## Technical Bulletin

B Revision Heaters: Wiring Issue

TB11.004

Figure 1. B Revision Heater Kit (AHTR151B)

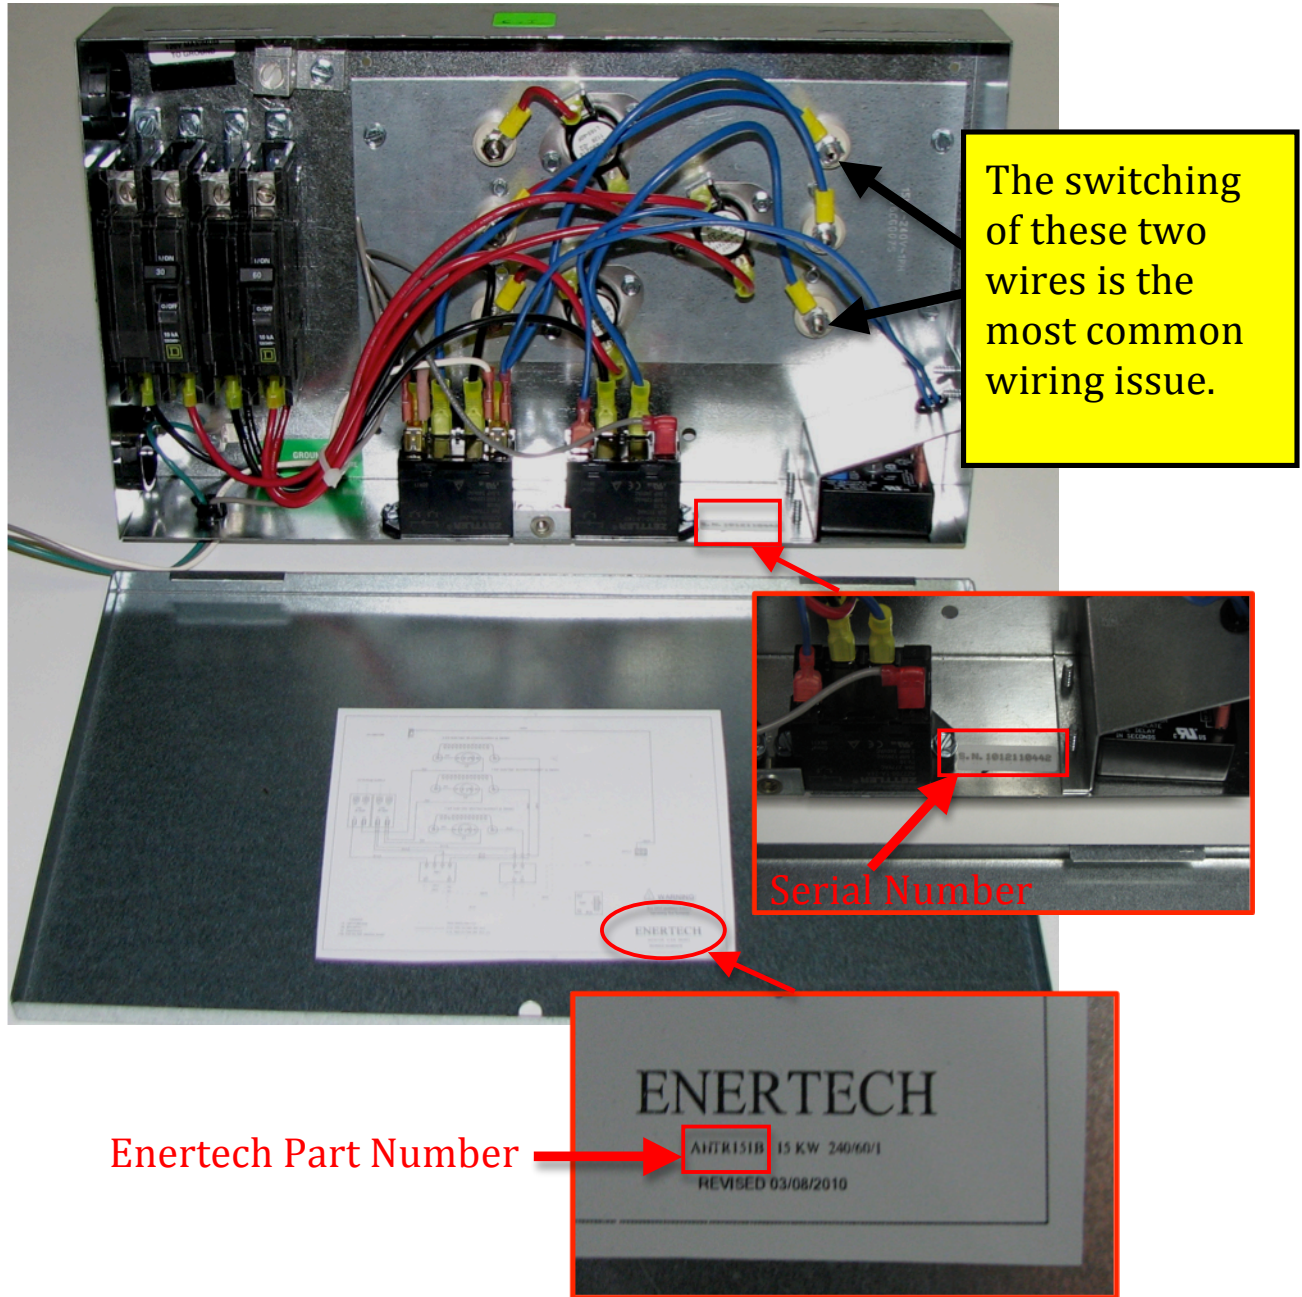
The B revision 15kW and 20kW heaters (AHTR151B & AHTR201B), which are compatible with the XT and CT models, may have incorrect wire placement inside the heater control box. The issues include incorrect point-to-point wiring and overstretching of some low voltage wiring. In some cases, the high voltage wires are placed on points in the heater kit inconsistent with the wiring diagram. This can create a polarity issue causing the heater not to energize. The low voltage wires should be checked for the correct point-to-point wiring, but the only concern found with low voltage wiring is overstretched wired between connection points. In order to correct the wiring issues, proceed with the following steps:

The switching of these two wires is the most common wiring issue.

1. Verify the EnerTech part number (see figure 1), which is located on the wiring diagram inside the front cover of the heater kit, matches the heater kit.
2. Inspect the kit wiring by comparing it to the wiring diagram.
3. Check for overstretched wires.
4. Make sure all connections are tight and secure.
5. Keep record of serial numbers (see figure 1) and part numbers of the kits corrected and list of corrective actions made to the wiring.
